**BOONETRAIL FARM LAKE DAM
WARREN COUNTY, MISSOURI
MO 30511**

PHASE 1 INSPECTION REPORT NATIONAL DAM SAFETY PROGRAM

SUBJECT: Boonetrail Farm Lake Dam Phase I Inspection Report

HS-8011

BOONETRAIL FARM LAKE
DAM PLAN & PROFILE

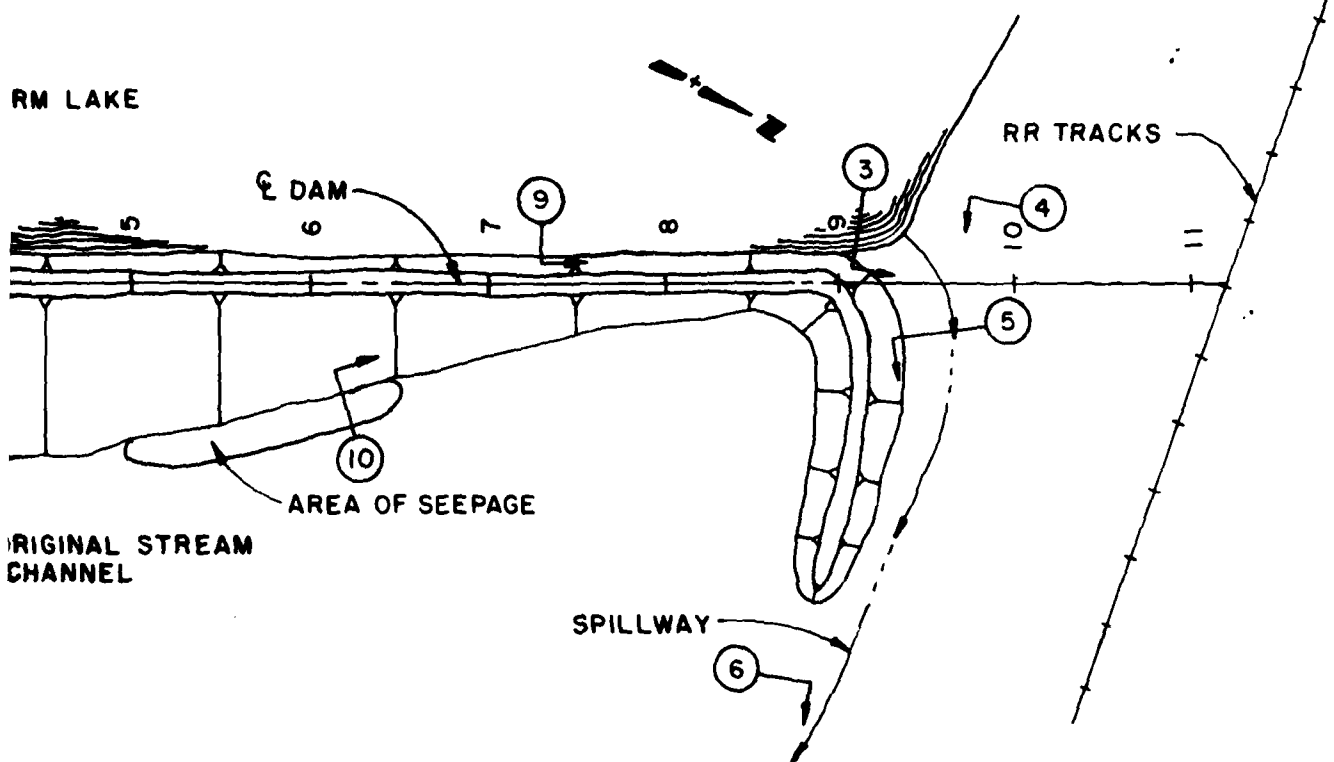
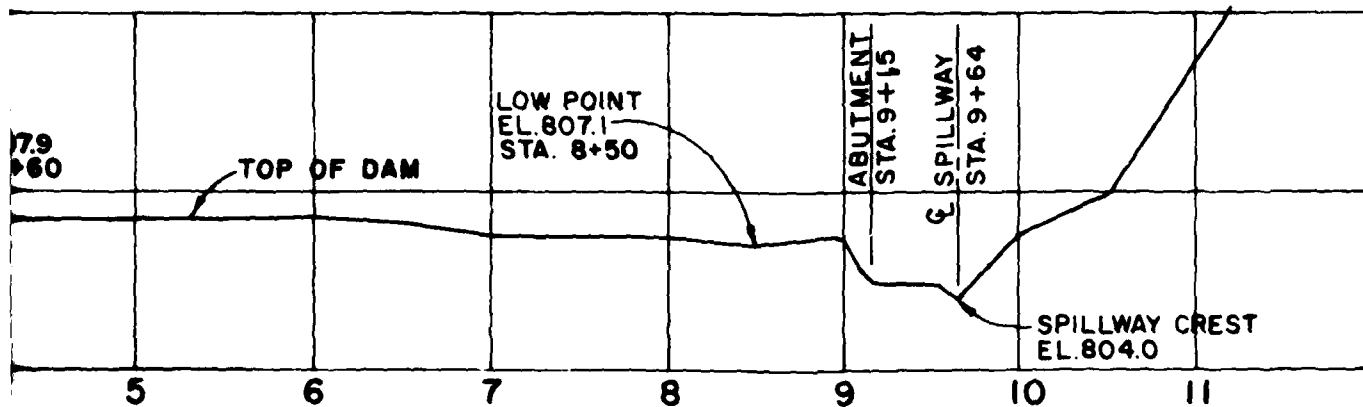
2. Erosion, presumably by wave action, has created a near vertical bank which varies from about 2 feet to approximately 4 feet in height along the upstream face of the dam. Loss of section by erosion can impair the structural stability of the dam.
3. An area of seepage with soft ground and standing water was observed to the left of the center of the dam, near the toe of slope. Uncontrolled seepage could develop into a piping condition that can lead to failure of the dam.
4. The dam, according to survey data obtained during the inspection, appears to have settled, on the order of 1.0 foot, in the vicinity of the original stream crossing, and the top of the dam near the left abutment was found to be considerably lower, about 1.5 feet, than the dam crest at the center of the structure. Low areas in the dam crest reduce freeboard and penalize spillway capacity.

Based on survey data obtained during the inspection, it appeared that, in the vicinity of the original stream crossing, the dam had settled approximately 1.0 foot. However, the lowest portions of the dam crest were found to be near the left abutment where the crest was about 1.5 feet lower than the top of the dam at the center of the structure.

(4) Restore the dam crest to a uniform elevation and monitor the top of the dam through the area of suspected settlement in order to determine the extent of possible future settlement and the remedial work required to compensate for such settlement. The crest of the dam should be uniform throughout without low areas that reduce dam freeboard and penalize spillway capacity.
